# Technical Memorandum

<b>To</b>	ABP	<b>Contact No.</b>	N/A
<b>Copy to</b>	DFDS	<b>Email</b>	N/A
<b>From</b>	GHD	<b>Project No.</b>	12578580
<b>Project Name</b>	DFDS Traffic Impact Study - Immingham		
<b>Subject</b>	ISH5 Action Point 28 and 29

Figure 1 Review of existing A1173 / Kiln Lane Roundabout

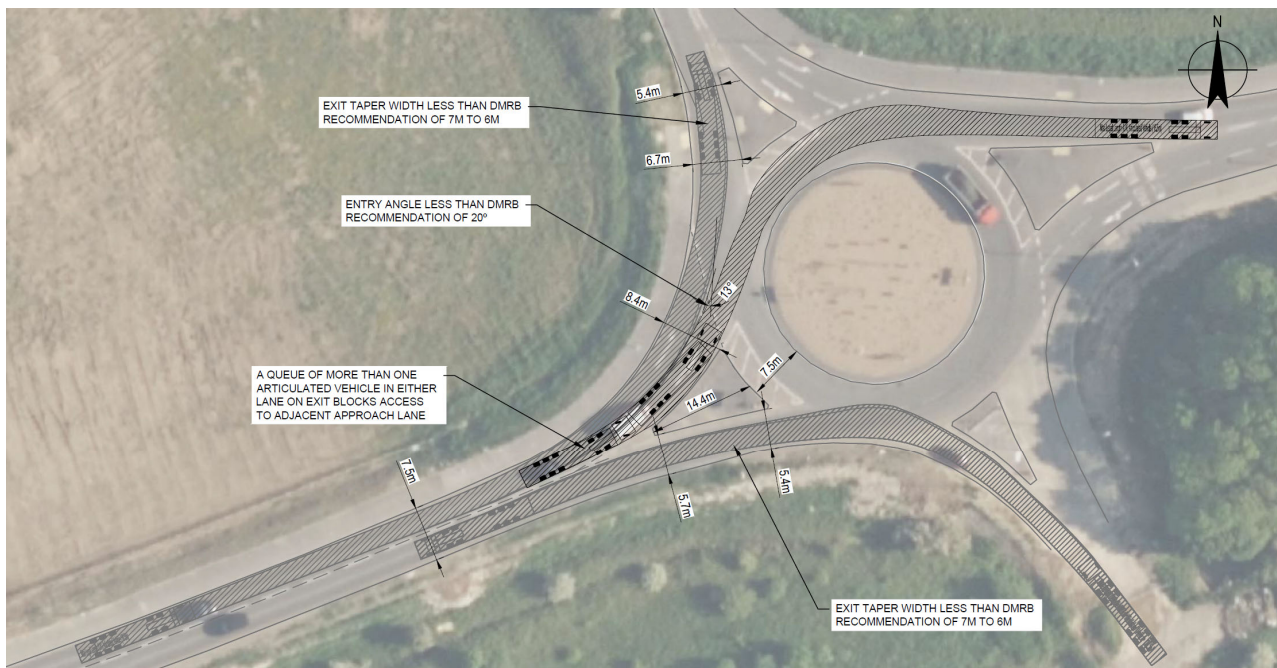
Table 1 (Table 4 of REP5-028) identifies that the A1173 West approach to the roundabout operates above its practical capacity during the AM peak hour (0.86 RFC), and the addition of the IERRT Development flows increase the RFC by 0.10 to 0.96 RFC. This results in an *increase* in delay of almost half a minute to some 41 seconds in total, and queuing of this approach *increasing* by 12.1 PCU equating to circa 5 articulated HGV's (based upon the PCU factor of 2.3 included in the Applicants assessment). The total queue would be 18.8 PCU.

A review of the existing configuration of this junction has been undertaken which shows that the A1173 West Arm (eastbound approach) only has capacity to accommodate two articulated HGV's side by side without blocking the adjacent lane (see figure 1 below). It is notable that if an HGV is sat in the ahead lane (for which there is significant existing demand), this blocks access to the left turn which is the predominant movement at this junction for access to the IERRT development.

In addition to this the existing entry angle is very shallow which restricts visibility particularly from the nearside left turning lane and this would be exacerbated by left hand drive vehicles. The intensification of left turn movements through this junction may therefore have safety implications which have not been considered at all by the Applicant in the form of a review of the suitability of the design of the existing roundabout to accommodate additional IERRT traffic. The increase in traffic and exposure to risk of collisions attributable to the IERRT should therefore have been considered particularly in the context of the occupation of NELC's flagship South Humber Industrial Investment Programme (SHIIP).

It is clear that the IERRT development does have a material impact at this sensitive junction and mitigation should be considered in consultation with NELC. To assist this process DFDS has presented a concept highway improvement scheme to address these issues whilst enhancing capacity. This is presented within drawing SK-U-00002 P2 in **Appendix A**.

Whilst this concept should be subject reviewed by the Applicant and a Road Safety Audit, the position of DFDS is that the Applicant should deliver these works prior to occupation of the IERRT.
